SS 581167 FCCC eB2 (Jouley) 47% SoC Battery CAN Integrity Improvement (294)

FCCC eB2 (Jouley)

EB2 Gateway Controller Update

47% SoC Resolution

ID:	FRONT_BOX_H_POWERTRAIN_CAN_TERMINATING_RESISTOR
PN:	23-12144-004
	SEALED CONNECTOR
Add on:	23-13302-114
	23-13302-402
	23-12202-002
CAV:	CIR#
A:	1920+ # 1603 (Y)
B:	1920+ # 1603 (DKG)

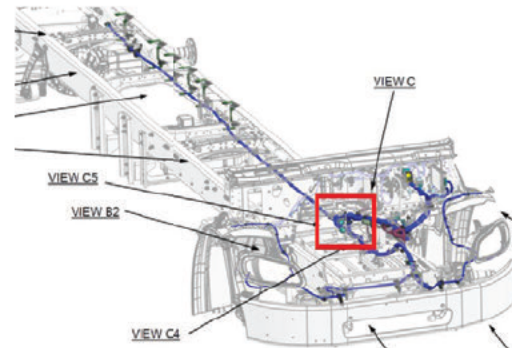
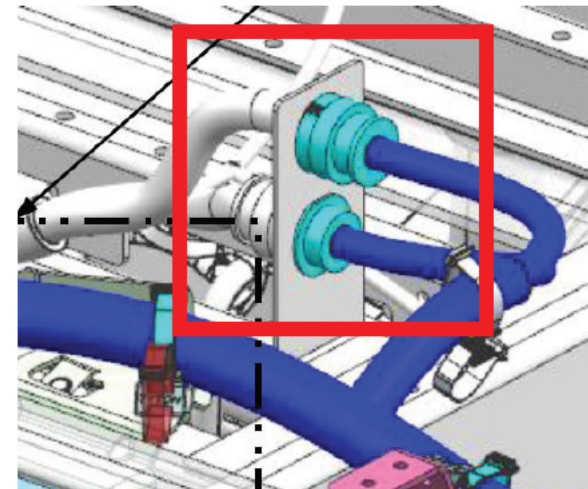
- Remove the terminating resistor from the BCAN circuit (FRONT_BOX_H_POWERTRAIN_CAN_TERMINATING_RESISTOR) located at the front box near the 47 cavity Chassis Interface Connector (FRONT_BOX_H_CHAS_H_INTERFACE_C1)

- Install the assembled moisture seal / dust cap connector from the previous steps
- Hardware update complete
